KEYSTONE XL PIPELINE PROJECT

KEYSTONE XL PIPELINE PROJECT PIPELINE ROUTE VARIATION FORM			
1	VARIATION TYPE: Refinement: <input type="text"/> Reroute: <input checked="" type="checkbox"/> Footprint: <input type="text"/> Design: <input type="text"/> Centerline: <input checked="" type="checkbox"/> Pump Station: <input type="text"/> Valve Site: <input type="text"/> CAR: <input type="text"/>		
2	LOCATION: Sketch: <input type="text"/> Pictures: <input type="text"/> N/A State: <input type="text"/> SD County: <input type="text"/> Harding Quad Map: <input type="text"/> N/A Township: <input type="text"/> (18N); 17N Range: <input type="text"/> 06E Aerial Map: <input type="text"/> See attached map sheet Section: <input type="text"/> (034,035); 02 Centerline: <input type="text"/> 3/14/2012 MP: <input type="text"/> 331.86 to <input type="text"/> 332.83		
3	REASON FOR ROUTE VARIATION (Please include reason for route variation): The primary reason for this reroute is to avoid crossing drainage multiple times and to avoid paralleling drainage. The reroute has been proposed based on the field reconnaissance effort.

KEYSTONE XL PIPELINE PROJECT ROUTE VARIATION AUTHORIZATION FORM		
Date: 3/20/2012	T

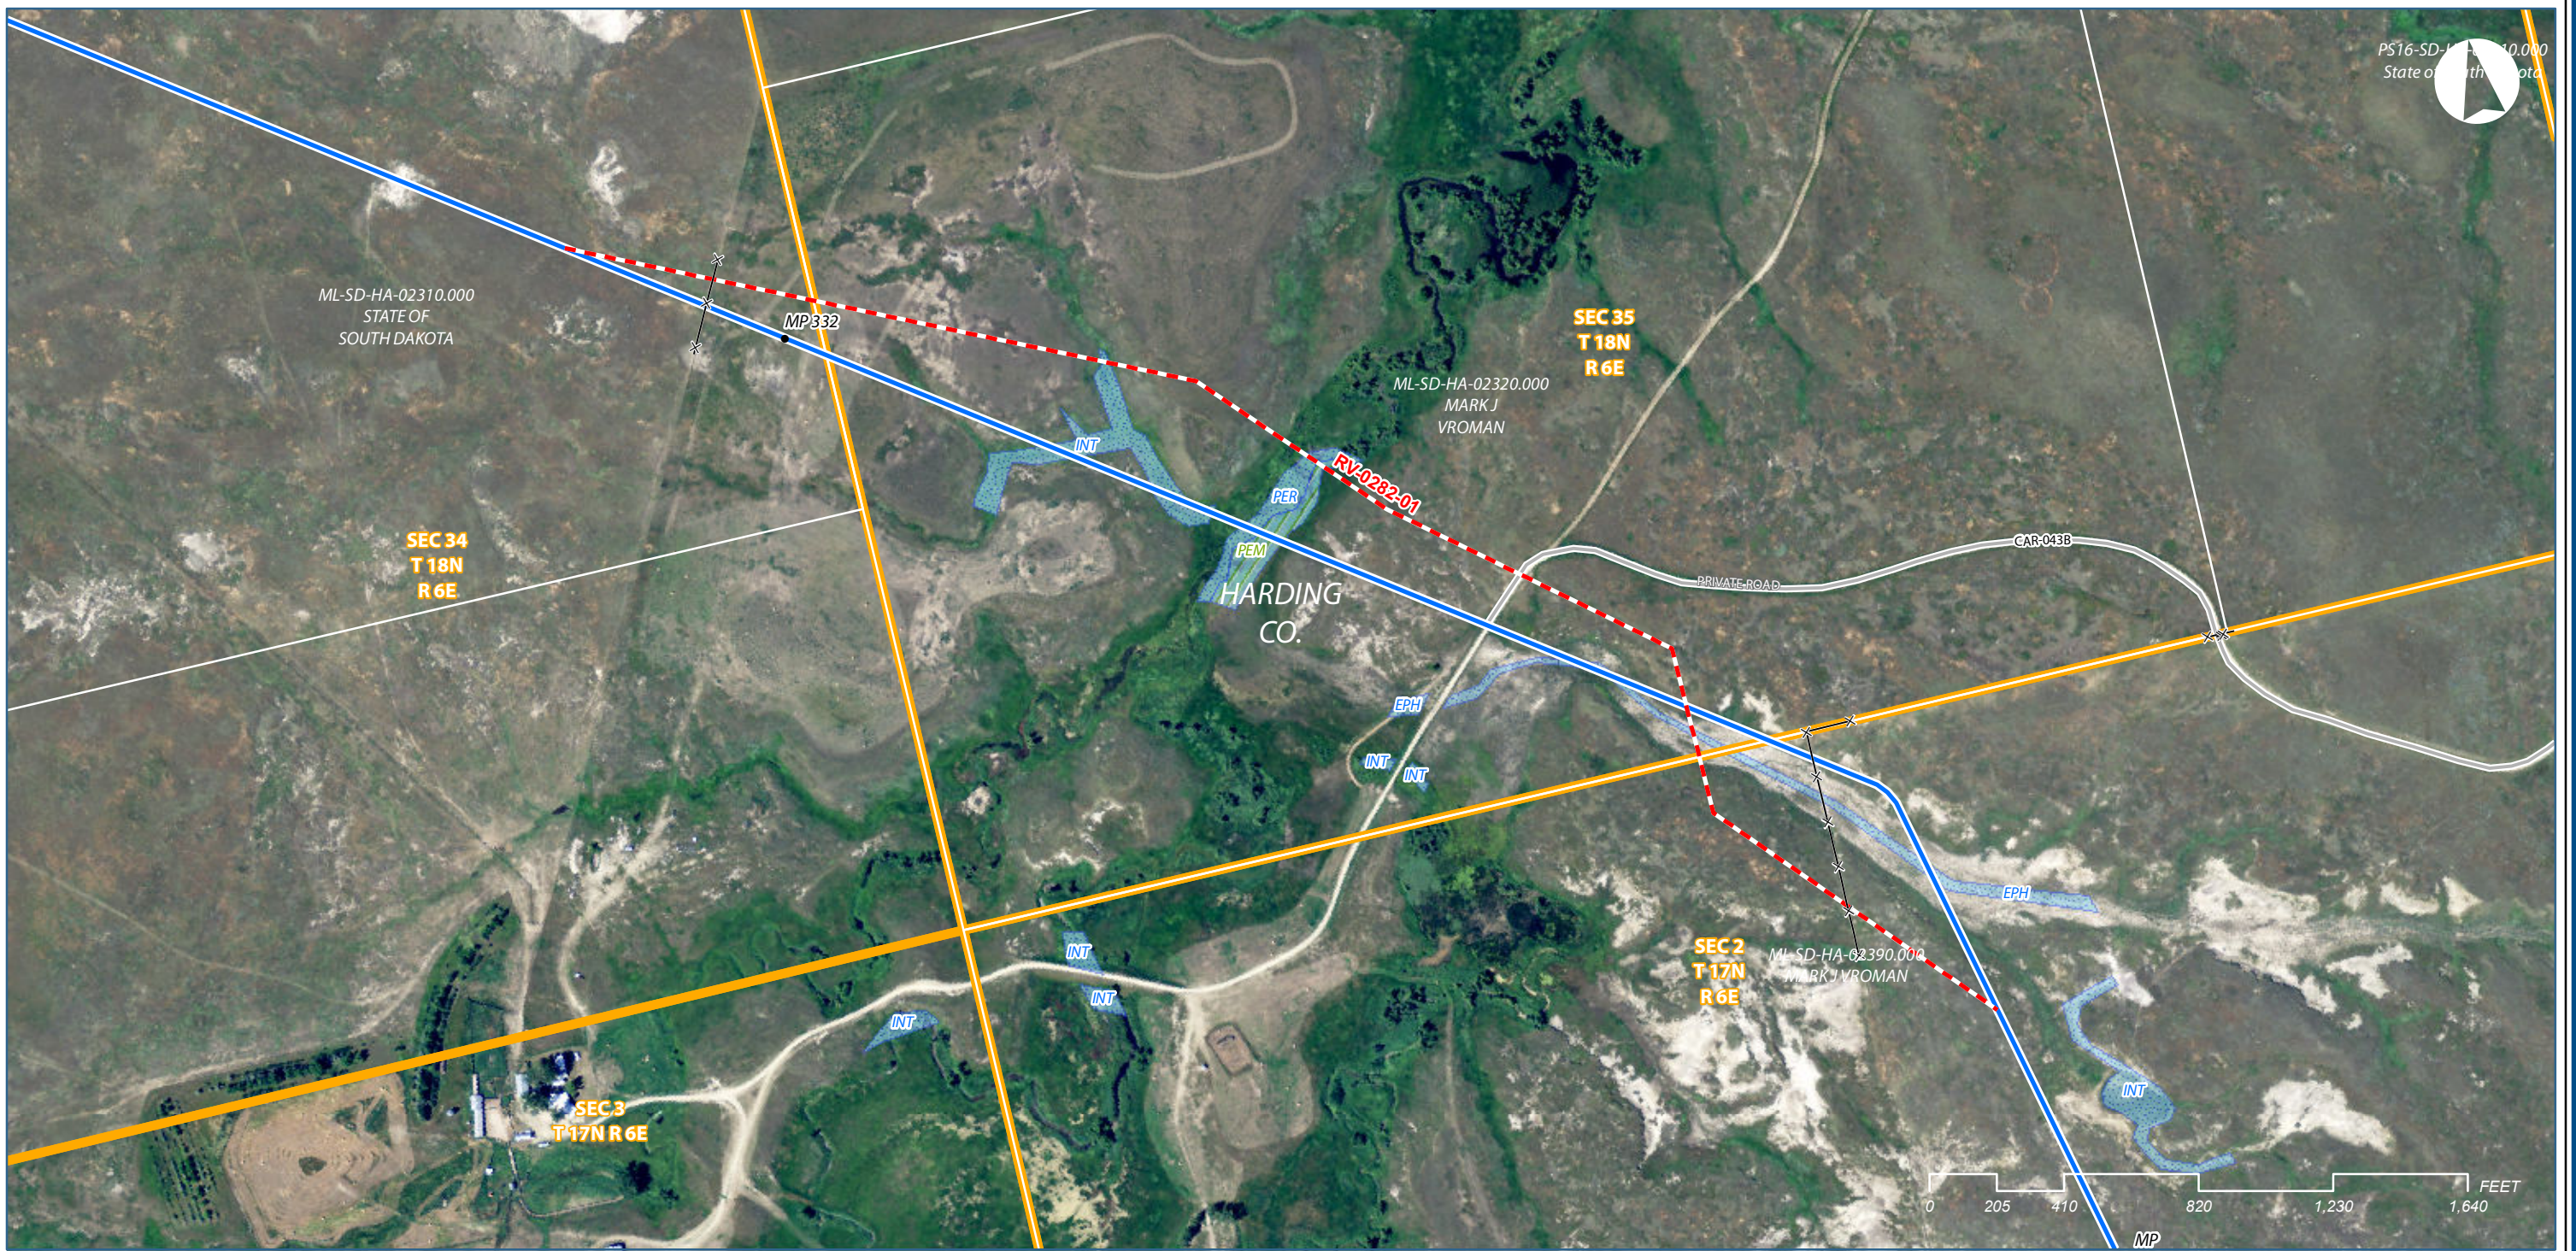
DETAIL ROUTE VARIATION (Please describe route variation in detail): Route variation starts near MP 331.9 and deviates ~10.5° southeast of CL. It continues in this direction for ~1,967 ft. This allows more distance and effectively avoids crossing a drainage of the West Squaw Creek twice. The reroute then turns further southeast for ~1,666 ft. The reroute continues by turning south, thus crossing the current CL. It extends in this direction for ~517 ft. before it makes a final turn east towards the current CL. In this direction extends for ~1,054 ft. and rejoins the current CL near MP 332.8.			
ADDITIONAL IMPACTS (Please include any additional impacts which may affect cost; crossings, induction bends, etc.): No New Landowners are impacted by this route variation. Three tracts are impacted by reroute: ML-SD-HA-02310.000 (State of South Dakota) ML-SD-HA-02320.000 and ML-SD-HA-02390.000 (both tracts: Mark J. Vroman)

Is there an increase/decrease in the number of crossings? Yes <input checked="" type="checkbox"/> No <input type="checkbox"/> If yes, please list: <input type="text"/> Reroutes eliminates 1 drainage crossing.			
COST ANALYSIS (costs incurred or saved from the route variation)			
Additional length of route realignment:	99	ft.	\$ 35,760.96 \$ 360/ft
Additional length of side-hill construction:		ft.	\$ - \$ 19/ft
Additional length of wetland construction:	-500	ft.	\$ (97,500.00) \$ 195/ft
Additional bore length (Road, RR):		ft.	\$ - \$ 540/ft
Additional foreign line/pipeline crossings:		EA	\$ - \$ 30,000/EA
Additional water body crossing (streams, ponds, etc.):			
35 - 65' +		EA	\$ - \$ 185,000/EA
10' - 19'		EA	\$ - \$ 77,250/EA
Less than 10'	-1	EA	\$ (32,500.00) \$ 32,500/EA
Additional survey required:			
Civil:	0.99	mile	\$ 4,934.15 \$ 5,000/mile
Cultural:	0.99	mile	\$ 2,467.07 \$ 2,500/mile
Biological:	0.99	mile	\$ 2,763.12 \$ 2,800/mile

a) Maximum deviation perpendicular to proposed alignment: 356 ft.
